APPLICANT: CAMFORD PROPERTY GROUP, INC 37 EAST CENTRAL STREET FRANKLIN, MASSACHUSETTS COVER SHEET PANTHER WAY FRANKLIN, MASSACHUSETTS PREPARED FOR CAMFORD PROPERTY GROUP, INC. 37 EAST CENTRAL STREET FRANKLIN, MASSACHUSETTS FEBRUARY 19, 2020 SCALE: 1" = 100'

Re: Panther Way Site Plan and Special Permit Application Peer Review

On behalf of the applicant Camford Property Group, Inc. we have provided responses to the following comments from the Franklin Town Engineer, Franklin Town Planner, Franklin Fire Department and BETA Group, Inc. The review comments are listed below and our response are immediately following each comment and have been italicized.

Re: Panther Way Site Plan and Special Permit Application Peer Review

SITE LAYOUT PLAN PANTHER WAY FRANKLIN, MASSACHUSETTS PREPARED FOR CAMFORD PROPERTY GROUP, INC. 37 EAST CENTRAL STREET FRANKLIN, MASSACHUSETTS FEBRUARY 19, 2020 SCALE: 1" = 40'

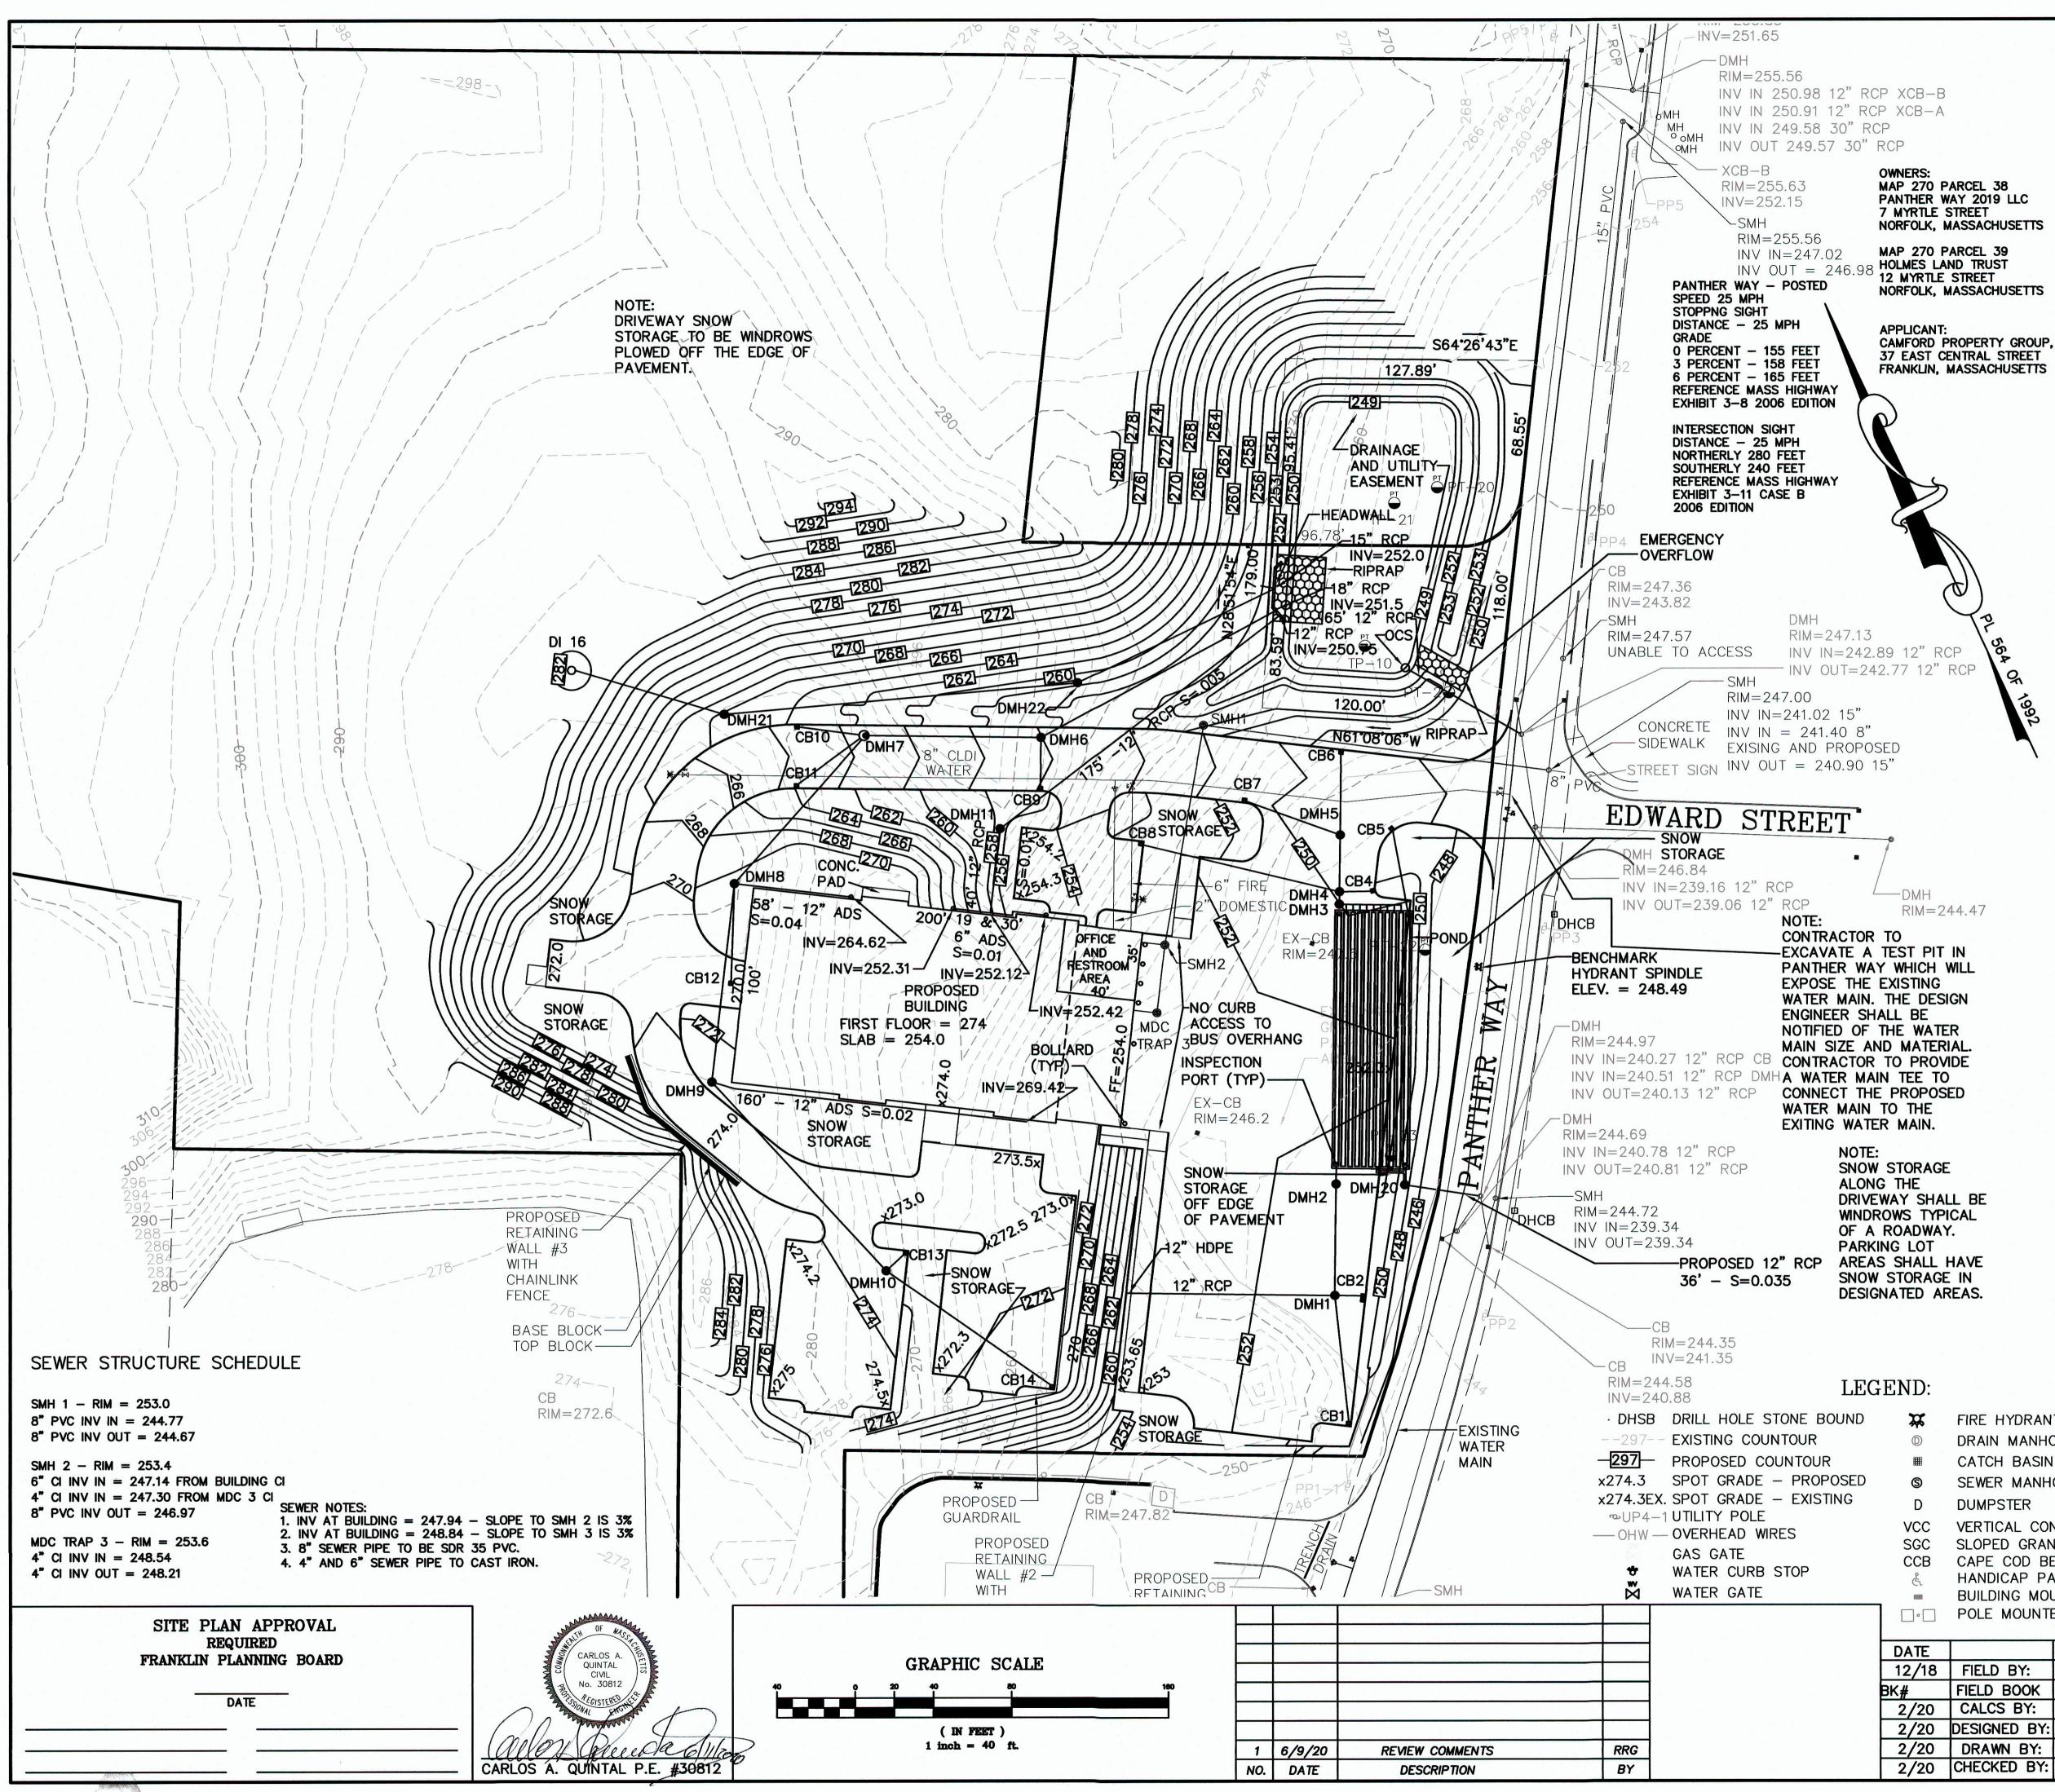
P3. Provide an area for vehicles to back out of the two parking spaces closest to the north side of the building.

DR3. Depict snow storage locations for parking areas on the plans §185-31.C.(3)(i).

Aisle width dimensions have been added to sheet SL-1.

The pavement area was revised to provide a turnout area. See sheet SL-1 and GU-1.

Snow storage locations have been added to SL1 and GU1.

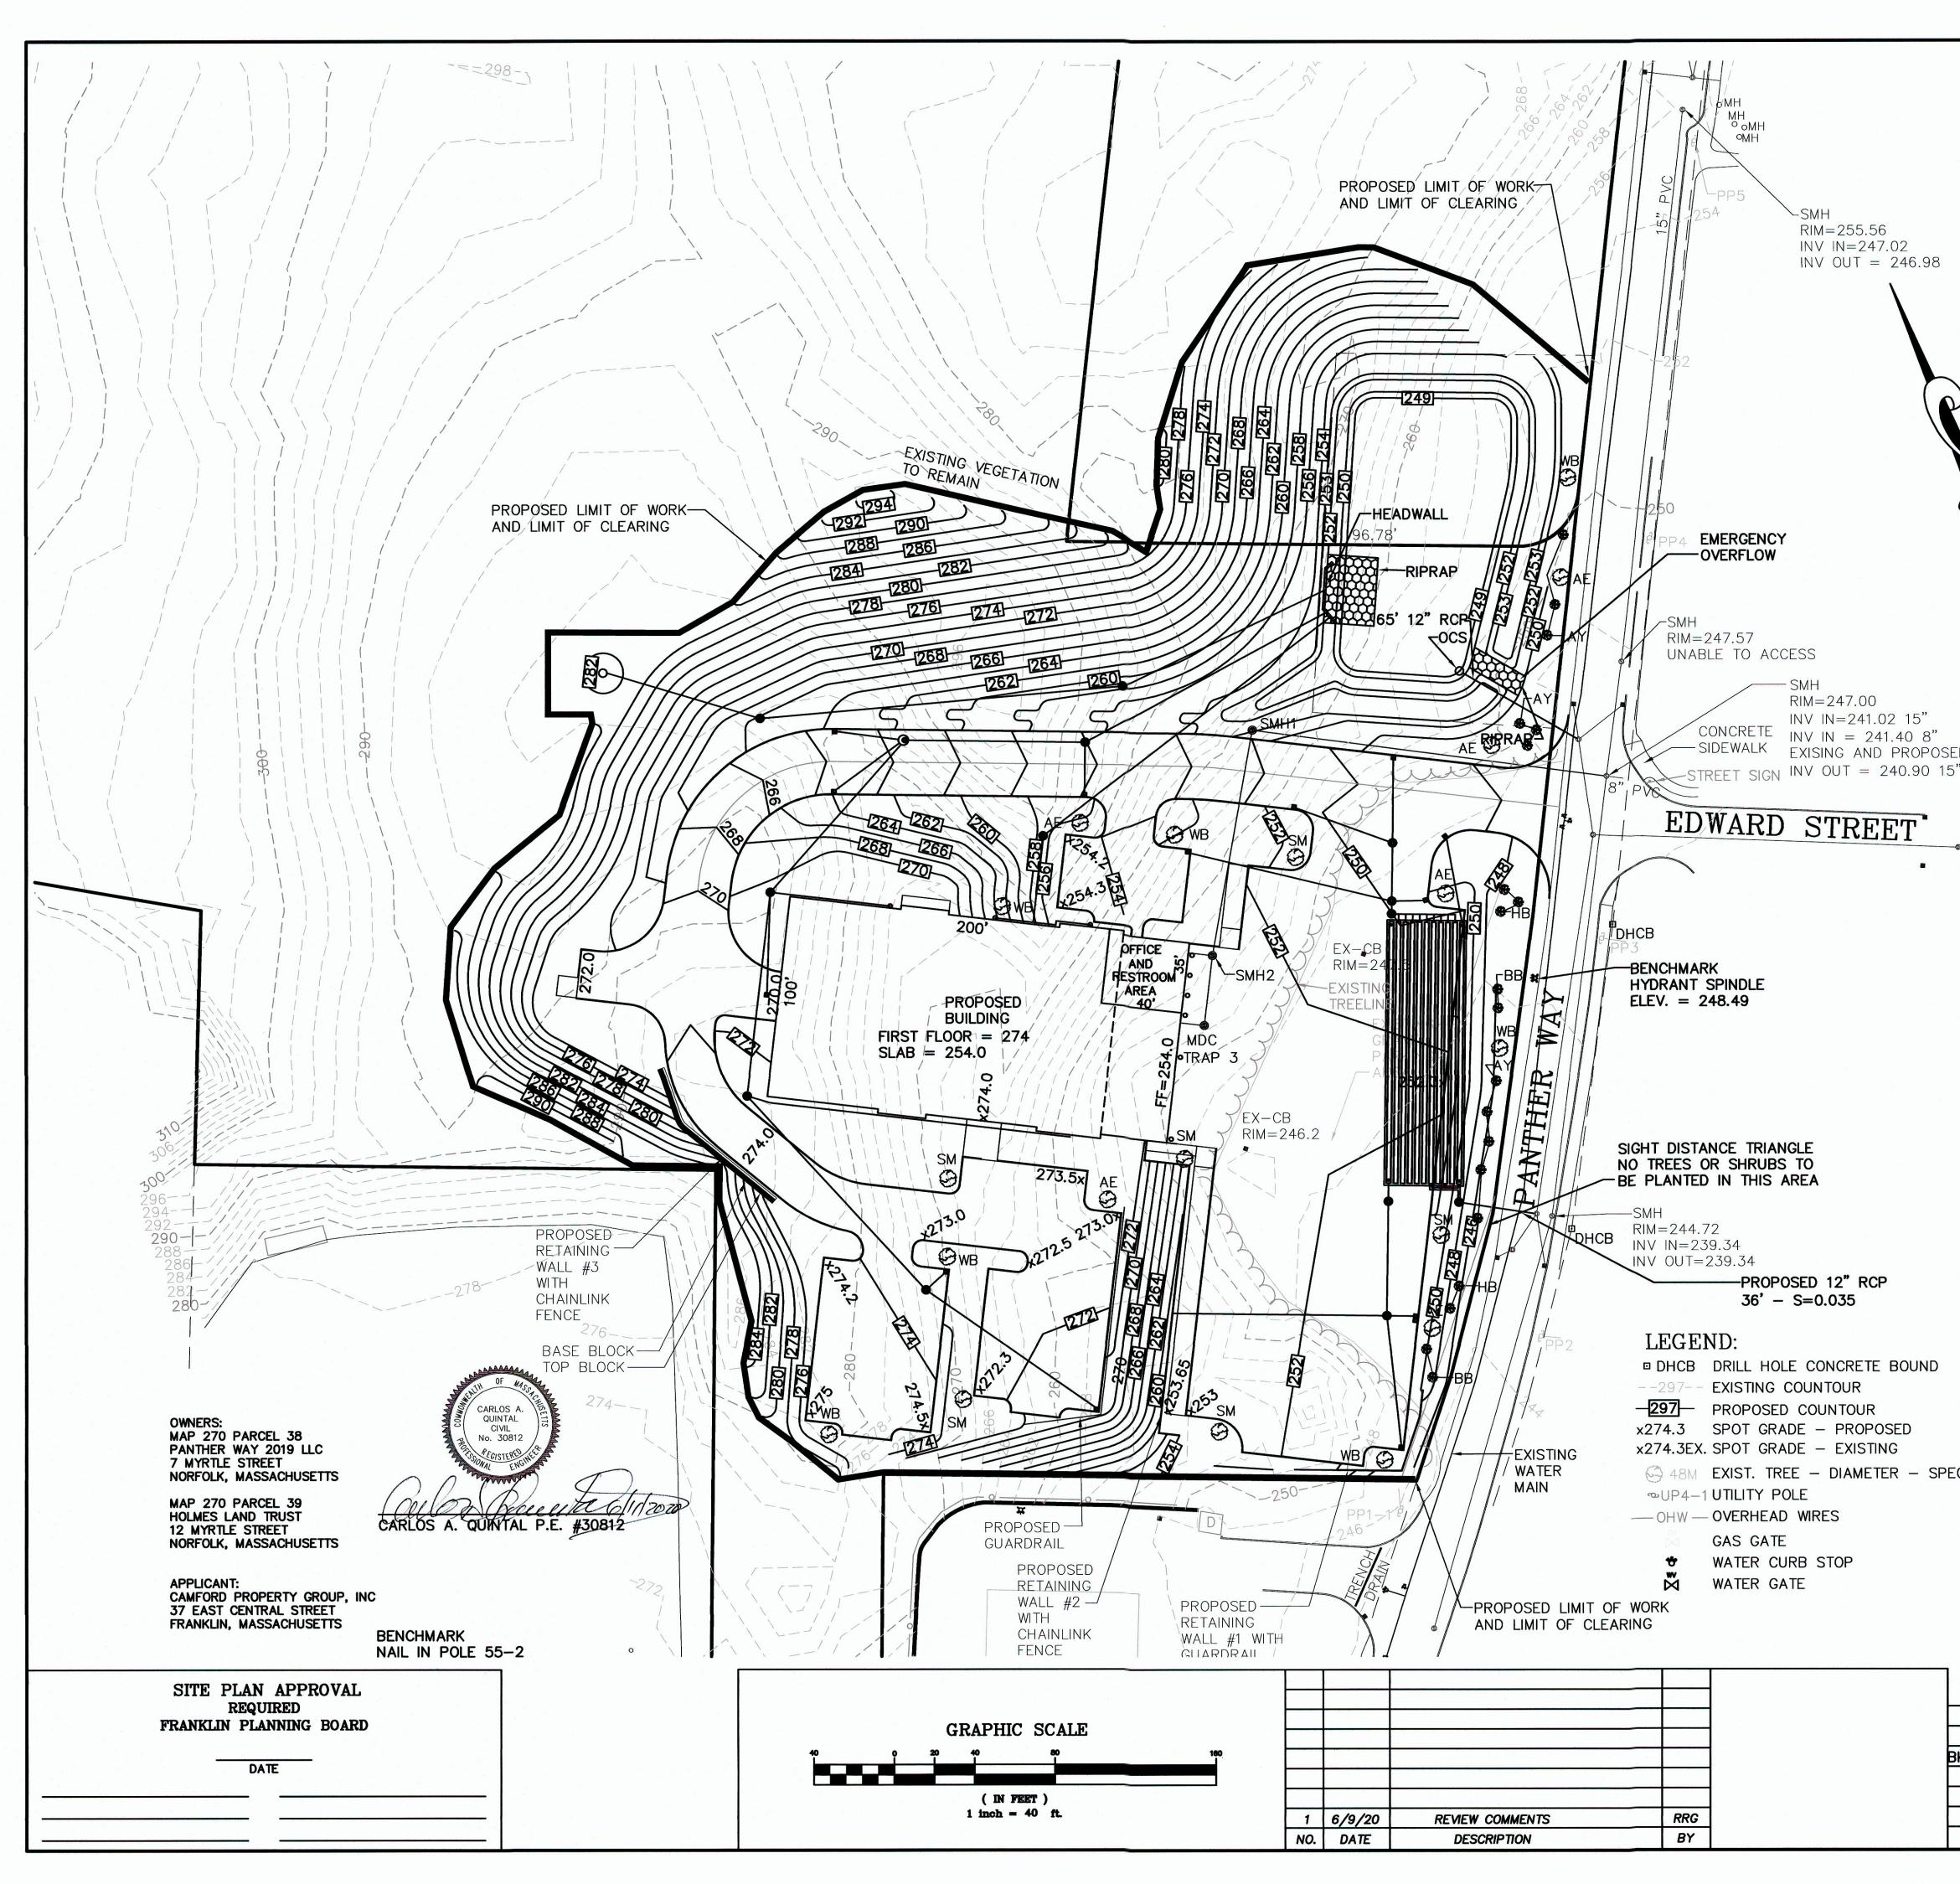
SW4. Recommend providing rim and invert information for proposed DMH-20 on the Grading and Utility Plan in addition to Pond Outlet Detail.

The rim and invert elevations have been added to sheet GU-1.
